1 **ADDENDUM NO. 1**

4 Project Identification: Alma City Hall Remodel – Phase One  
5 Project Number: 25020  
6 Project Location: 1225 South Main Street, Alma, WI 54610  
7 Owner's Representative: Mayor Rick Champeny  
8 Architect: Lien & Peterson Architects, Inc.  
9 Supervising Professional: William Boettcher, PE  
10 Date of Addendum: February 12, 2026.

**1 PLUMBING FLOOR PLAN (REMODEL)**  
P201 1/8"= 1'-0"  
TRUE NORTH PLAN NORTH

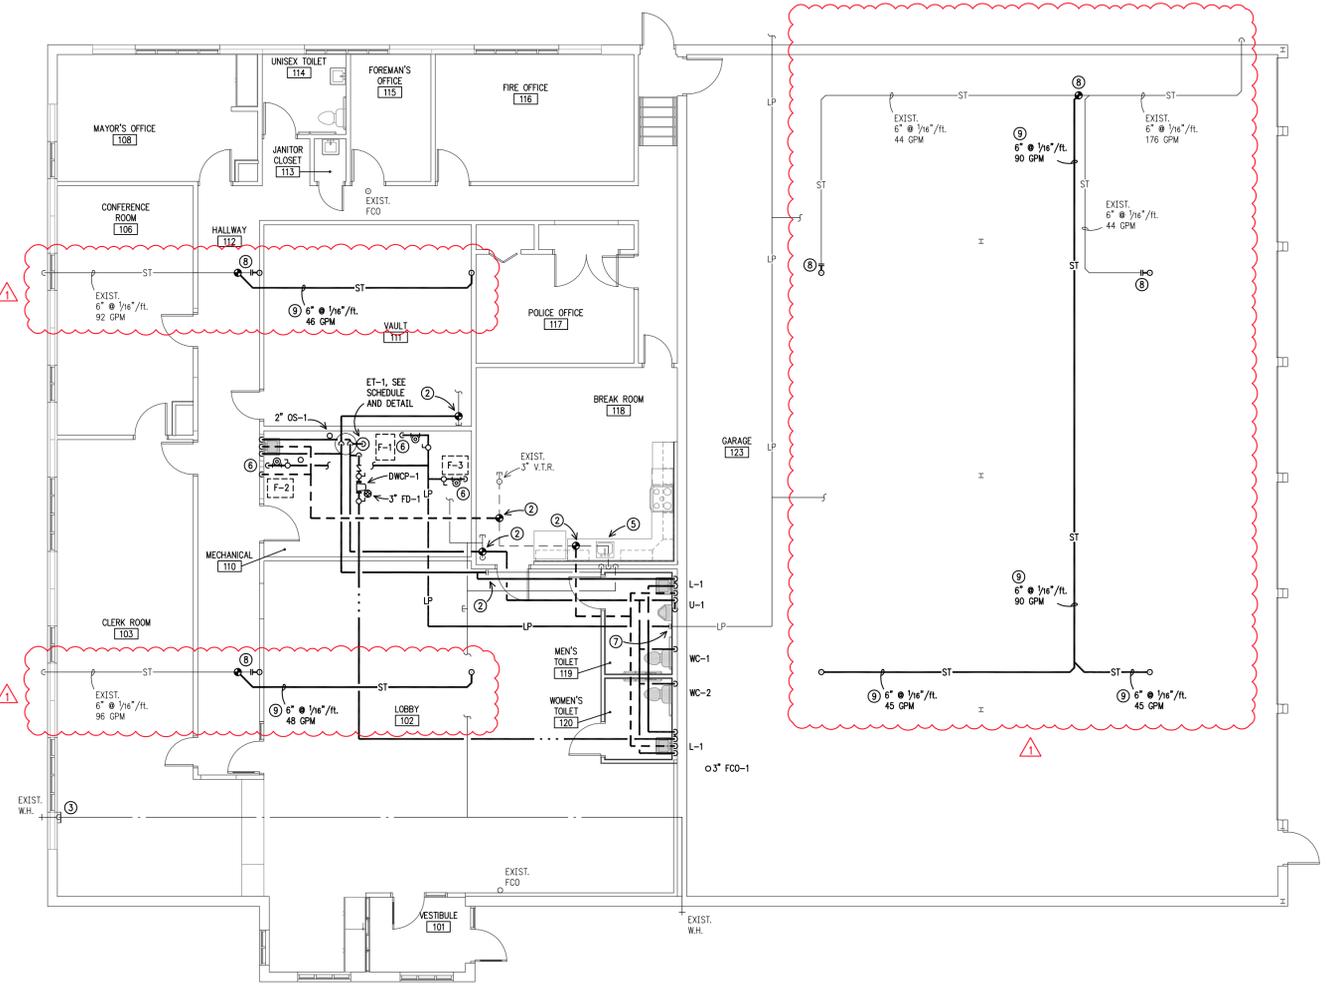
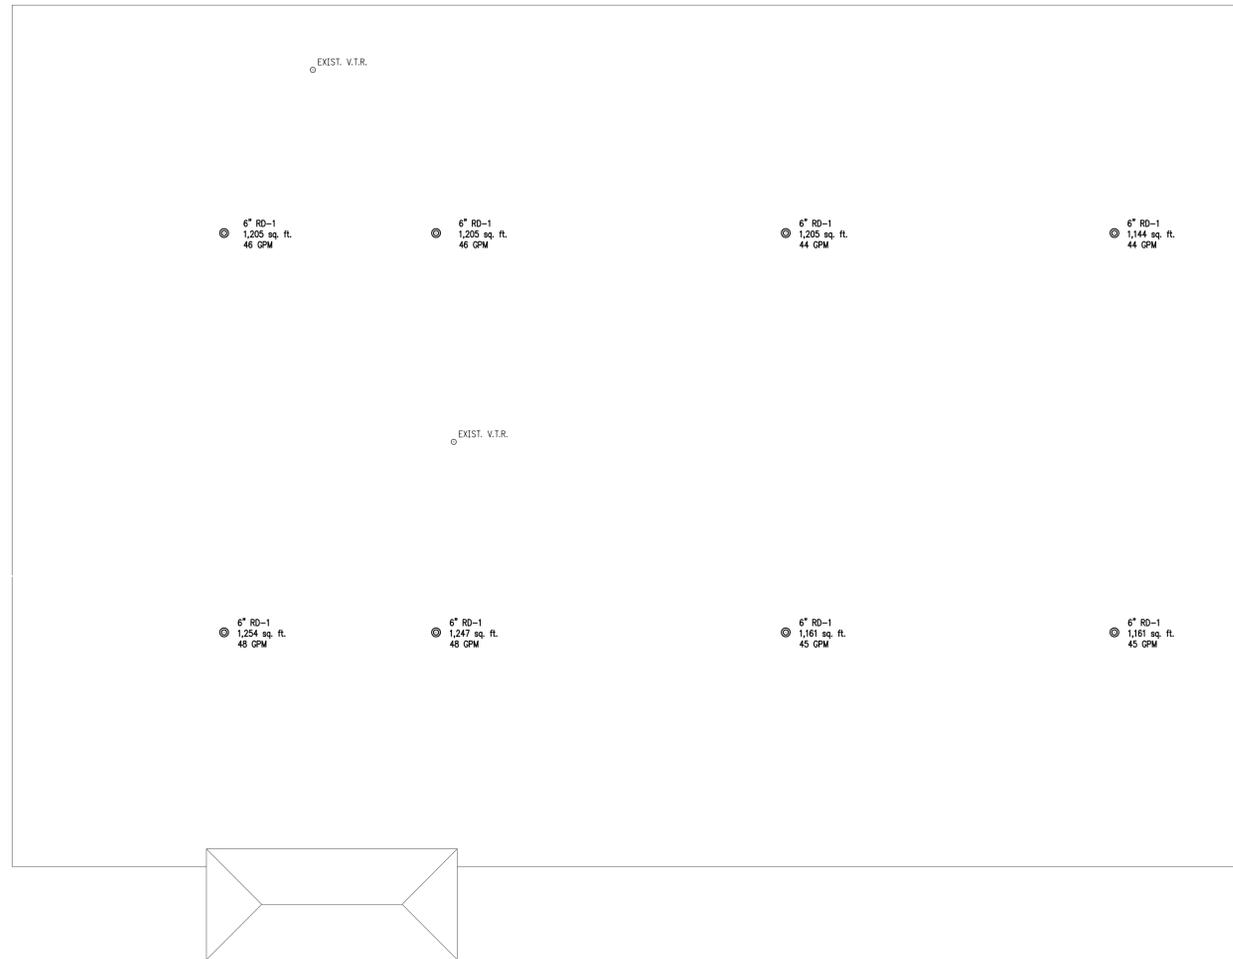
- 25 conditions.
- 26 Sheet P201 – Plumbing Remodel Floor Plans, (reissued).
- 27 Plumbing Remodel Notes: Note 8 added; Connect to existing storm piping as shown. Confirm exact

- 28 location, material, and condition prior to making final connection. Note 9 added; Run new storm
- 29 piping as high as possible.
- 30 Plumbing Floor Plan, (remodel): Floor plan has been revised to more accurately reflect existing

- 31 conditions; four new roof drains have been added. Roof plumbing has been revised in correlation
- 32 with existing roof conditions.
- 33 Sheet P202 – Plumbing Roof Plan Remodel, (new).
